CHANGE NOTIFICATION

PCN#: 110811

Subject: Notification of Internal Die change for LTM2882

**Figure 1. Error Example: T2IN Changes 20ns Before T1IN
(On This Time Scale, T1IN and T2IN Appear to Be Coincident)
Causing the T10UT and T2OUT to Be Delayed By $1.2\mu\text{s}$**

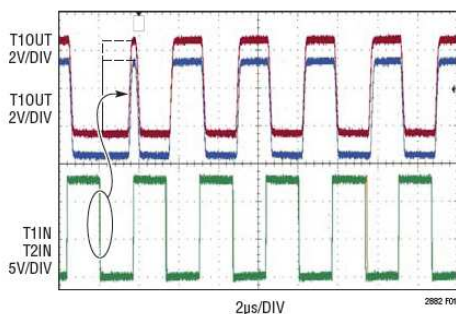
Some LTM[®]2882 devices have an internal timing race condition that can cause signals passing through the isolation barrier to be delayed or inverted for up to one refresh period of $1.2\mu\text{s} \pm 0.15\mu\text{s}$. This condition can occur if there is a specific narrow alignment of signal transitions and only if this is coincident with the rising edge of an internal asynchronous clock. Because of the tight alignment tolerance requirements and asynchronous nature of this event, this error is very infrequent. Workarounds are described below. The LTM2882 is being revised to correct this issue. Contact Linear Technology Corporation regarding availability.

An example of an error is shown in Figure 1.

Most LTM2882 devices will never exhibit this behavior. However, to eliminate these errors in all devices, follow these guidelines:

1. Operate T1IN avoiding high and low times that are multiples of $1.2\mu\text{s} \pm 0.15\mu\text{s}$.
2. Do not change T2IN or DIN 20ns \pm 5ns before a transition on T1IN.
3. Do not change T2IN or DIN $1.2\mu\text{s} \pm 0.15\mu\text{s}$, or multiples of this, before any transition on T1IN.

4. Operate R1IN avoiding high and low times that are multiples of $1.2\mu\text{s} \pm 0.18\mu\text{s}$.
5. Do not change R2IN 20ns \pm 50ns before a transition on R1IN.
6. Do not change R2IN $1.2\mu\text{s} \pm 0.2\mu\text{s}$, or multiples of this, before any transition on R1IN.
